#### **Addendum 29 – UN Regulation No. 30**

#### **Revision 3 - Amendment 11**

Supplement 25 to the 02 series of amendments – Date of entry into force: 24 September 2023

#### **Uniform provisions concerning the approval of pneumatic tyres for motor vehicles and their trailers**

Annex 3,

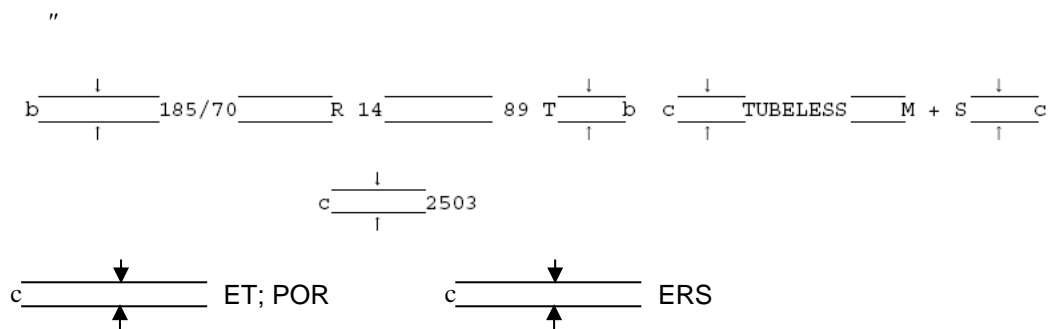
Paragraph 1., replace the figure by the following:

b = 6 mm (min.)  
c = 4 mm (min.)"
